Type of Submission: Notice of Intent

Type of Action: Plug and Abandonment

Plug and Abandonment Procedure
for
DJR Operating, LLC
West Bisti Coal 25 1
API # 30-045-28559
NW/NE, Unit B, Sec. 25, T25N, R13W
San Juan County, NM

BLM FLUID MINERALS Geologic Report

DJR Operating, LLC
Proposed Wellbore Diagram

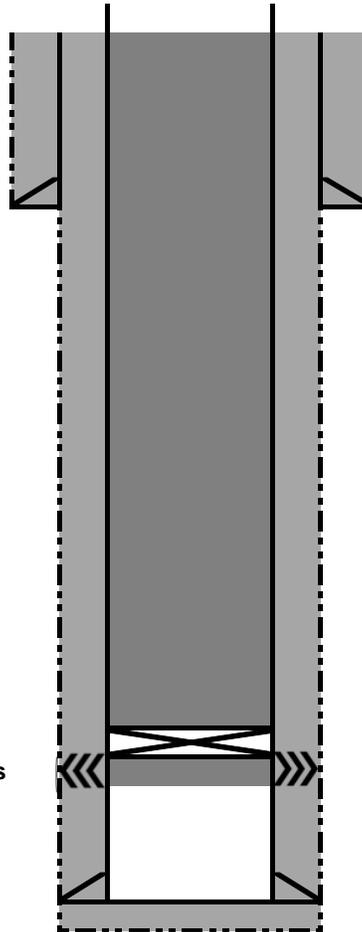
- P&A procedure has cement from the cement retainer @ 1130' to Surface which will protect any freshwater sands in this well bore.
- Fruitland Coal perforations @ 1162'-1181'.
